## Application for Works Approval Amendment

### Part V Division 3 of the *Environmental Protection Act 1986*

<b>Works Approval Number</b>	W6464/2020/1
<b>Works Approval Holder</b>	Calidus Resources Limited
<b>ACN</b>	006 640 553
<b>File Number</b>	DER2020/000476
<b>Premises</b>	Warrawoona Gold Project  G45/345, L45/523, M45/547, M45/552, M45/668, M45/669, M45/670, M45/671  MARBLE BAR WA 6760
<b>Date of Report</b>	6 April 2022
<b>Decision</b>	Revised works approval granted

**Figure 1: Proposed construction details for the hyporheic monitoring bore**

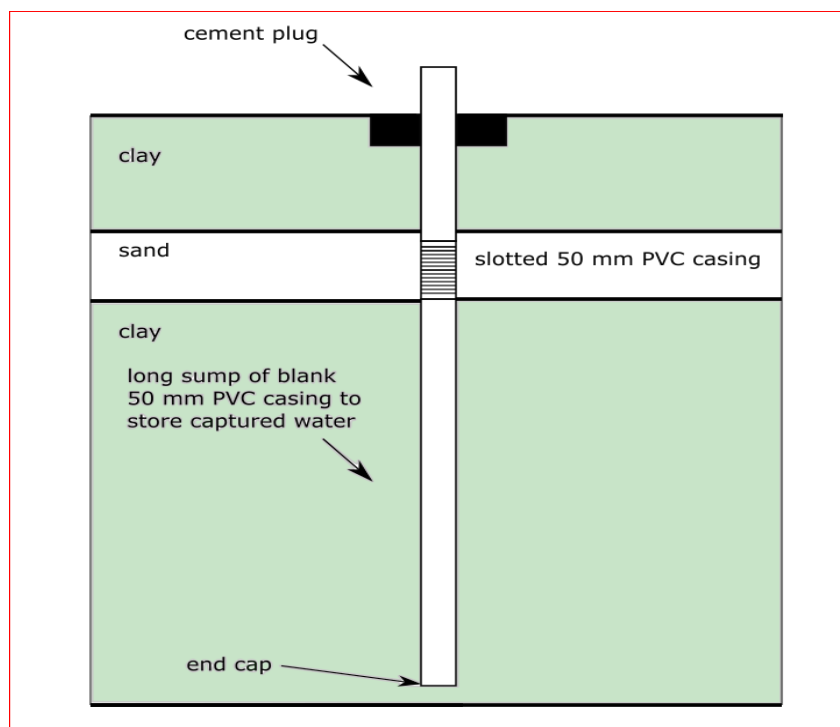
- Given the likely difficulty of accessing the creek at the drilling site, locating the bore on the edge of the creek bed is considered to be a suitable compromise. It is likely that such a bore would intercept alluvial sediments from historical creek lines, and that these sediments would be in hydraulic connection with sediments in the current creek line;

- Alluvial sediments at the site may only be periodically saturated, and that a bore constructed at the site may only be able to provide groundwater samples intermittently. It is therefore important that the bore is constructed in a manner that will maximise the likelihood of obtaining suitable groundwater samples when the alluvial sediments are saturated after a creek flow event; and

- It is recommended that the bore is constructed with a long section of blank PVC casing below the slotted interval (a “sump”: see Figure 1 below) to enable episodic groundwater flows to be captured within the bore. To obtain and store sufficient water for chemical analysis, it is recommended that this sump is at least two metres long. The section of slotted PVC casing above the sump should also be at least two metres long.

As the bore would be constructed in a non-standard way, it would not be possible to obtain groundwater samples from the bore using a conventional pumping technique. The recommended sampling method would be bailing using a stainless-steel bailer. To obtain suitable samples, it would be important that sampling is undertaken as soon as possible when a creek flow event takes place to ensure that stagnant water is not retained in the sump for a long period. The sump should be evacuated after sampling has been completed, to ensure that stagnant water is not retained to mix with future inflows of water to the bore.

It is recommended that the bore is sampled opportunistically whenever it contains water, which would probably only be during and immediately after a creek flow event. However, it is recommended that the presence of water in the bore is assessed on a frequent basis between creek flow events to determine whether additional sampling would need to be undertaken.
